Date Issued :	March 18, 2022	PCN Number :	511762
Reason for Change :	Change to Product Capacity change or tool replacement		
Description of Change :	This notification is to inform you about changes that are being made to the part(s) as identified in the list based on the replacement of aged tooling. This change will not affect the Fit, Form or Function of the product but Will affect the Appearance of the product at the Locking Latch location.		
Assessment of Change :	First Article Inspection		
Planned Implementation Date :	September 30, 2022		
Sample Availability Date:	August 19, 2022		
Internal Molex Qualification Date :	August 05, 2022		
Last date to request Samples by Customer :	September 23, 2022		
Traceability Code Markings / Date :	Cavity identification

- **5557 Series**
- Mini-fit JR 3ckt receptacle

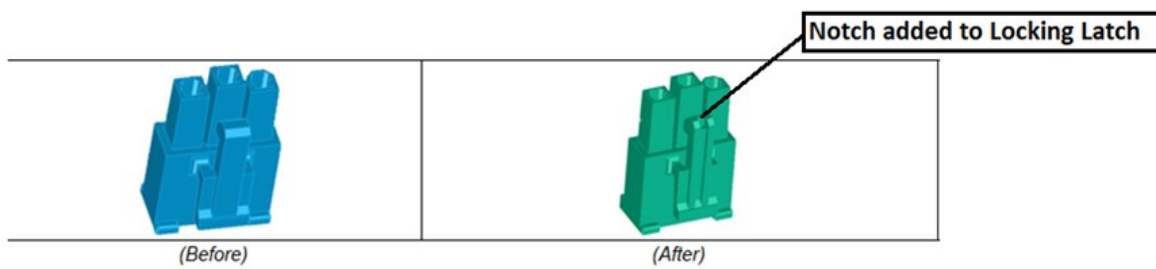
- To ensure business continuity, Molex Lincoln Nebraska is needing to replace tooling for the Mini-Fit Jr 3ckt receptacle due to the age of the current tool.
 - New tooling will be changed to improve mold flow during part production
 - Product from the New tooling from Lincoln Nebraska will have a notch added to the Locking Latch
 - Notch in Locking Latch is to improve mold flow and reduce short fill of product
 - Product made from other locations will not have this notch
- Change will impact Appearance of the part at Locking Latch location
- There will be NO change to the Fit, Form or Function of the parts
- Part Numbers Impacted
 - See attached list
- Qualification and Samples available upon request after date shown above
 - Last date for sample requests will be September 23, 2022
